Access Compliance Report

Public Rights-of-Way

(Curb Ramps)

Intersection ID: 31839	Main Street: RUGGED_STONE_WY	Cross Street: SILVER_FALLS_WY	Location: E
ADA ID: 2001DF77EAED	Ramp Type: PerpDiag	Initial Pass/Fail: Fail	Overall Compliance: No
Codes/Mitigation Info/Possible Solution		Field Measurements/Component Compliance	
Severity Score: 21.25

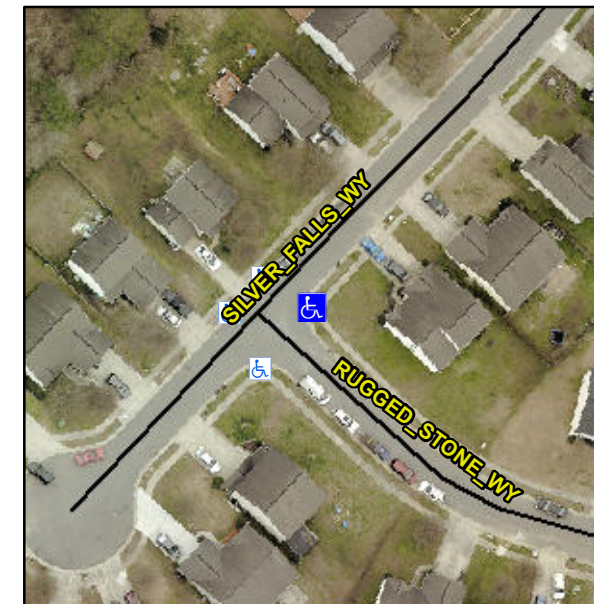
R304.5.1, R304.2.2

Compliance	Description	Data	Compliance	Description	Data
N/A	Ramp Length (in)	46.0	No	Ramp Slope (%)	8.7
No	Ramp Width (in)	41.0	Yes	Ramp XSlope (%)	0.5
N/A	Flare Type LT	N/A	N/A	Flare Type RT	N/A
N/A	Flare Slope LT (%)	N/A	N/A	Flare Slope RT (%)	N/A
N/A	Flare Traversable LT?	N/A	N/A	Flare Traversable RT?	N/A
N/A	Landing Length (in)	N/A	N/A	DWS Provided?	N/A
N/A	Landing Width (in)	N/A	N/A	DWS Contrast?	N/A
N/A	Landing Slope (%)	N/A	N/A	DWS Length (in)	N/A
N/A	Landing X Slope (%)	N/A	N/A	DWS Full Width?	N/A
N/A	Landing Curb? (Y/N)	N/A	N/A	DWS Offset (in)	N/A
N/A	Shared Landing?	N/A			
N/A	Gutter Ponding?	N/A	N/A	Gutter Slope (%)	N/A
N/A	Gutter Lip Ht (in)	N/A	N/A	Gutter X Slope (%)	N/A
N/A	Painted X Walk1?	No	N/A	Painted X Walk2?	No
	X Walk 1 Direction	To NW		X Walk 2 Direction	To SW
N/A	X Walk 1 Width (in)	N/A	N/A	X Walk 2 Width (in)	N/A
	X Walk 1 Slope (%)	1.4		X Walk 2 Slope (%)	0.3
	X Walk 1 X Slope (%)	0.9		X Walk 2 X Slope (%)	0.9

Remove & Replace Curb Ramp With Two New Directional Ramps or Equivalent.
